**BULLETIN**

NUMBER 18

**SUBJECT:** Replacement Tail Brace Wire Nipples

**MODELS AFFECTED:** J2 Cubs, Serial Nos. 1500 to 1999 and  
J3 Cubs, Serial Nos. 2000 to 2609

FIN TIE ATTACHMENT

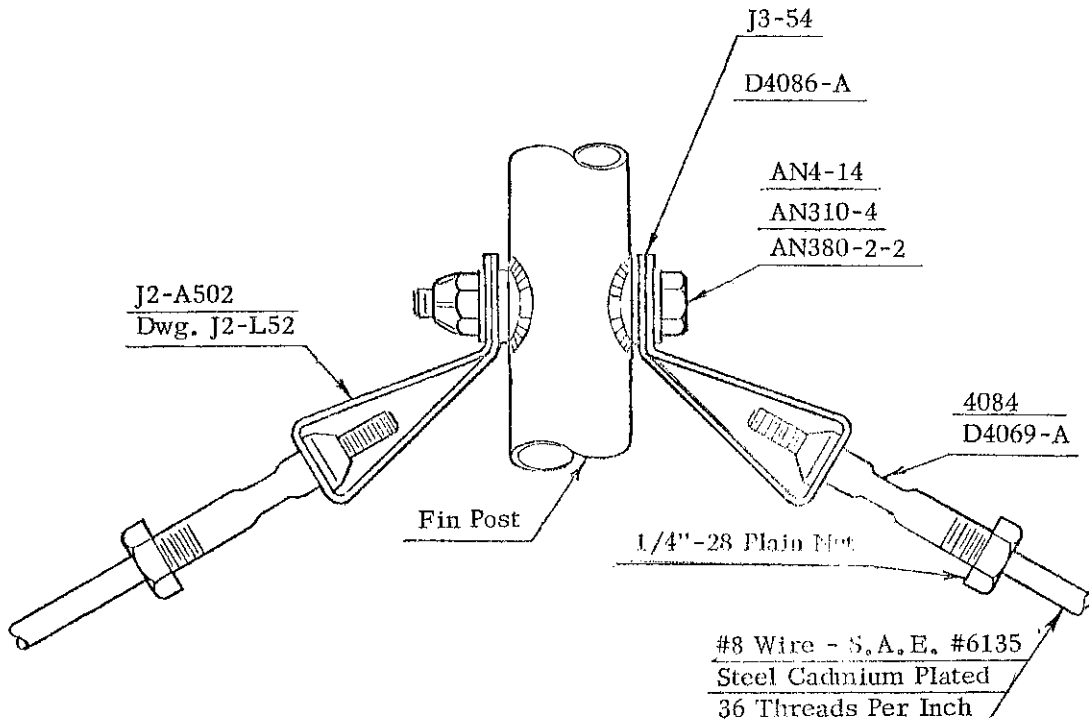
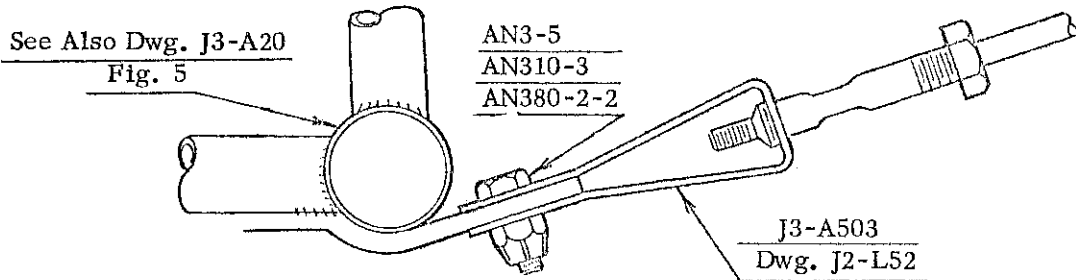
A considerable number of fatigue failures of the tail brace wires at the threaded section have been reported to this office. These failures have in most instances been caused either by ground handling or vibration.

This new nipple is long enough to completely cover the threaded section of the wire and has a lock nut on one end which clamps the body of the nipple to the solid section of the wire.

In order to afford a greater margin of safety in the operation of our Cubs, we have designed a new type of tail brace wire nipple which we are recommending that you install at once, in order to avoid a similar failure in your installation.

We would also like to call to your attention that by the installation of the new nipple the CAA will no longer require that the tail brace wire be replaced every 250 hours of service.

Note: This new type nipple can be installed on your present type wire.
